## ***Oil and Gas Well RAIs***

### ***Formulation of RAI***

Comments concerning oil and gas wells within 2 km of the Proposed Project area:

**LUDEMAN PROJECT**  
CONVERSE COUNTY, WY

DRAWN BY	PC/CAT	Wyoming Oil and Gas Conservation Commission Permitted Wells Within Two Miles			
DESIGNED BY	WFC	Source: Wyoming Oil and Gas Conservation Commission, 6/11/2013			
APPROVED BY	RMD	REV #	DESCRIPTION	BY	DATE
		0	Draw for Review	RMD	6/20/13
		1	For Submission	RMD	6/20/13
		2			
		3

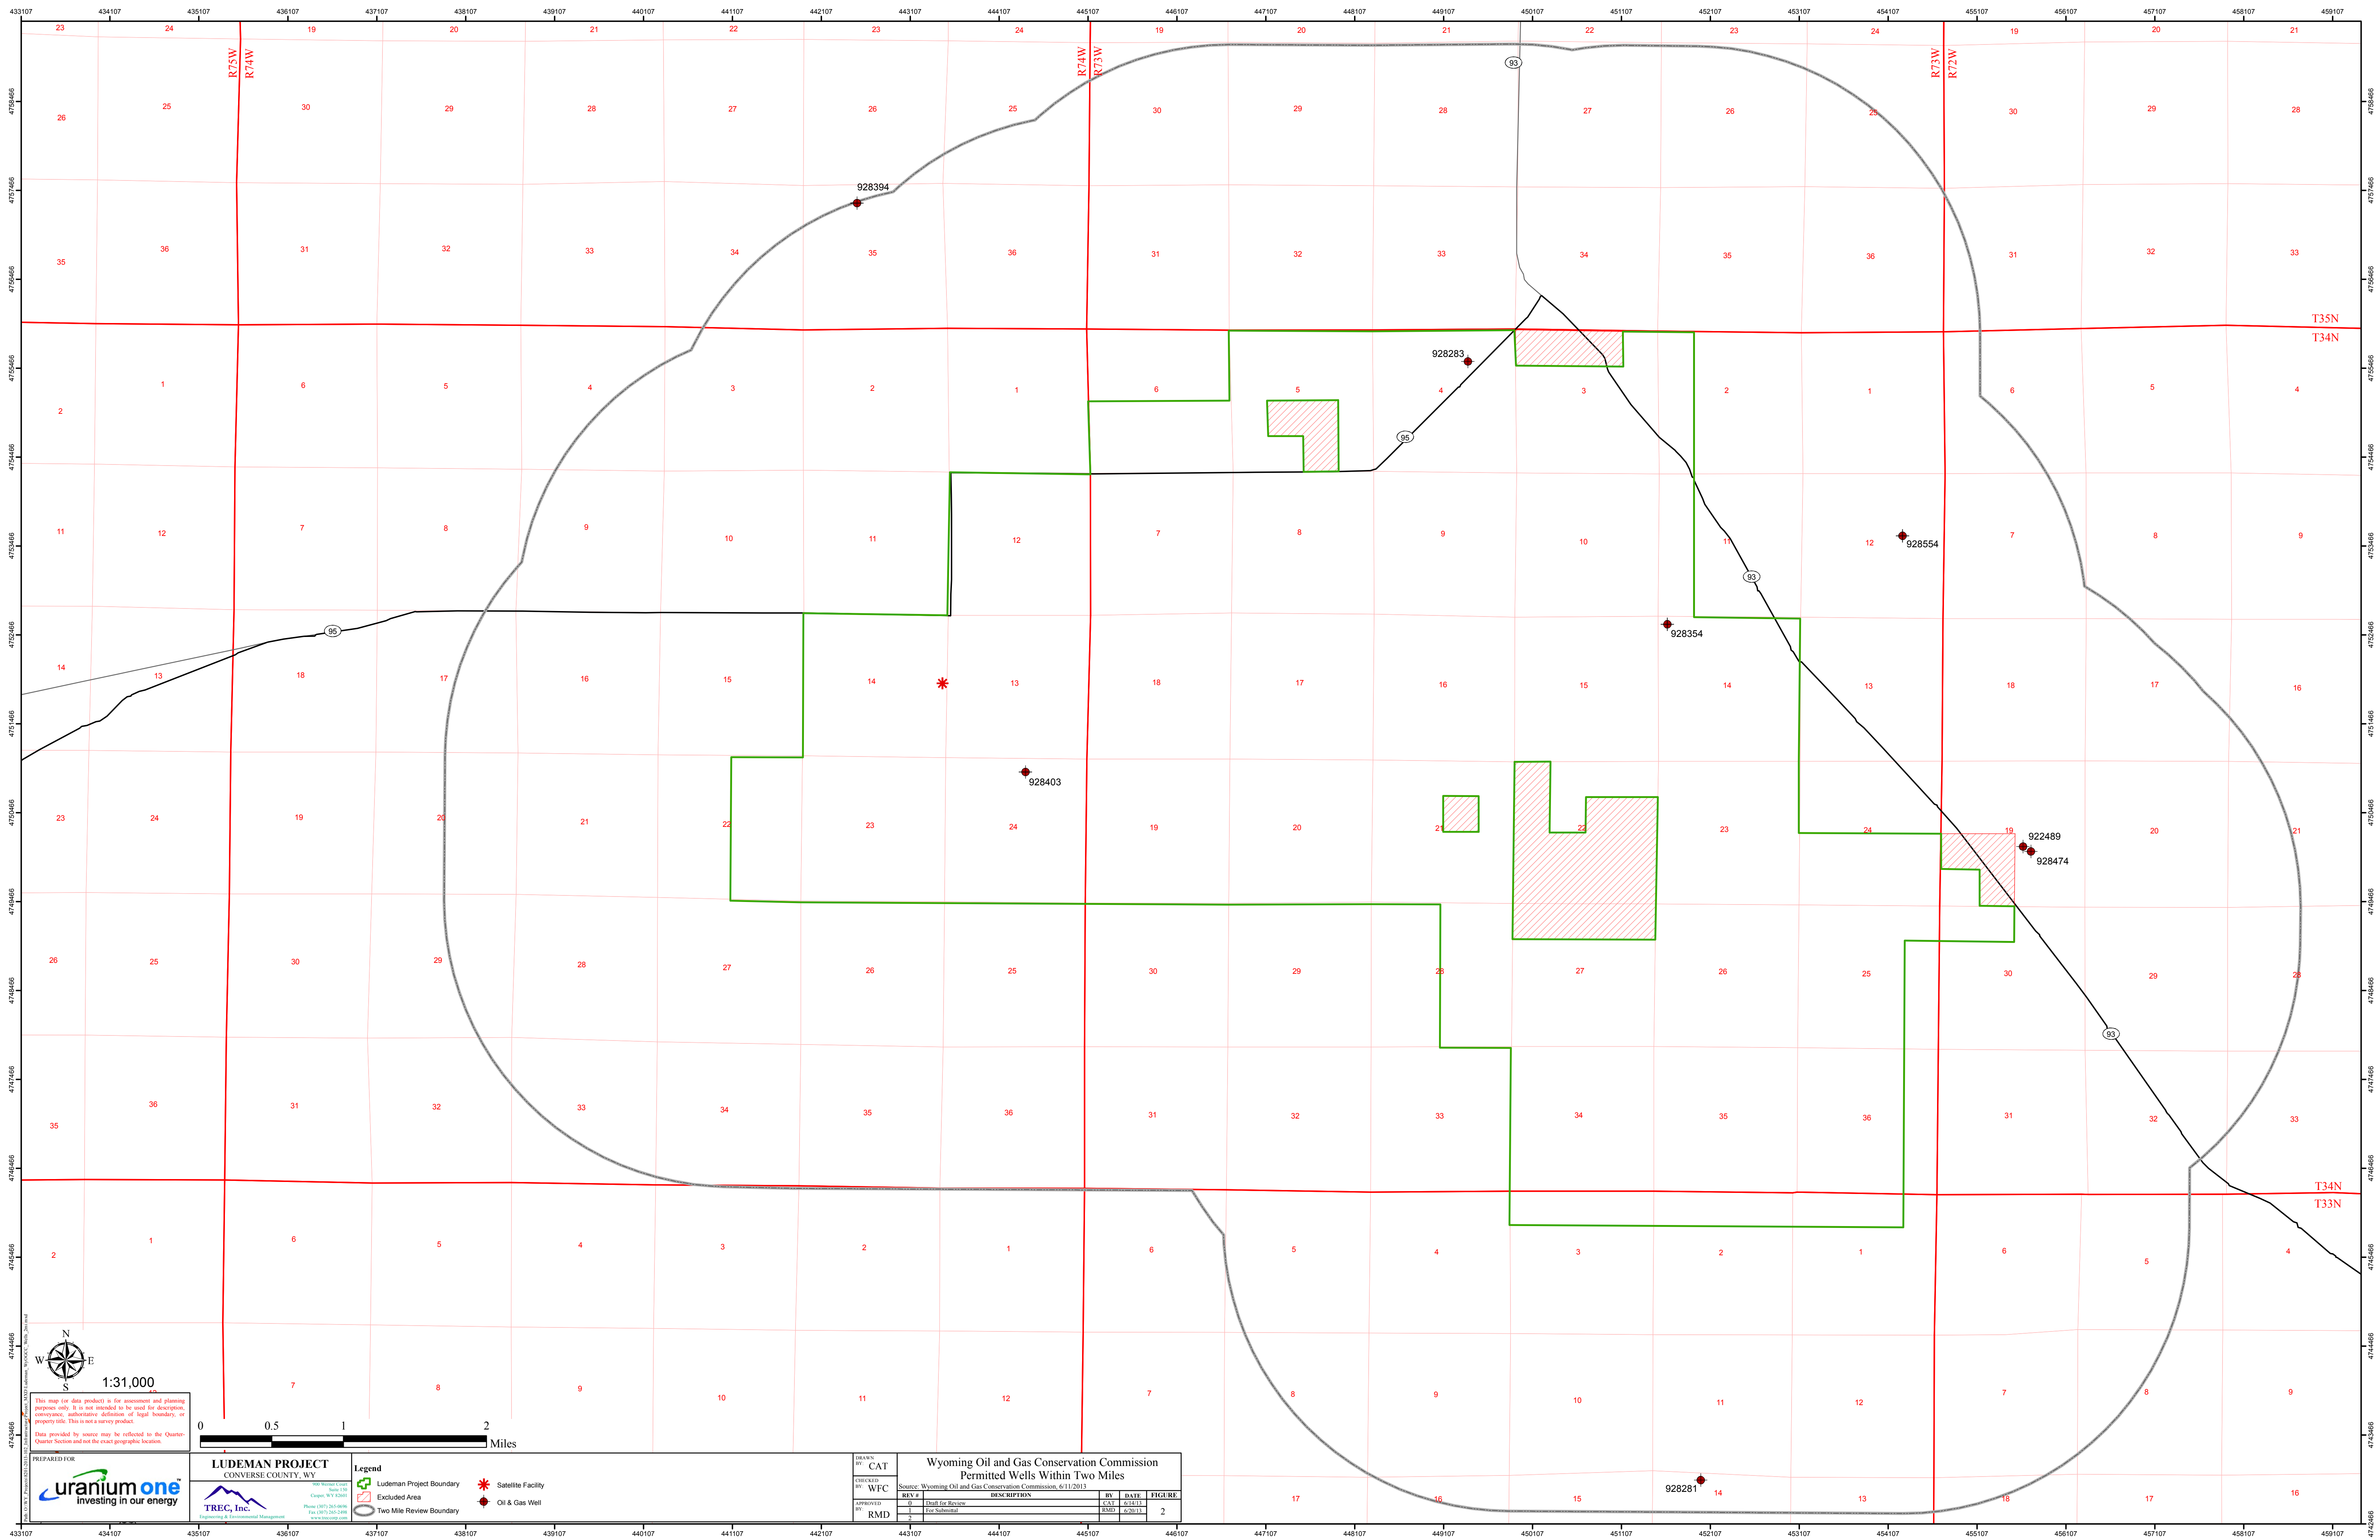
- a) What is the status of the following wells?
  - API 922889
  - API 928353
  - API 928414
  - API 928566
- b) Are there lateral wells and if provide lateral info ( distance and length).
- c) Please confirm correct depth and completion of API 928283. Does not appear to be completed in the Niobrara.
- d) Are the following wells screened in the Niobrara?
  - API 928394
  - API 928474
  - API 928554

The correct depth and completion information for API 928283 has been updated and provided in the following table. This table has been updated with the most current WOGCC data and will replace the current table within the application. In addition to the table, the associated figure depicting the location of the listed wells is provided below
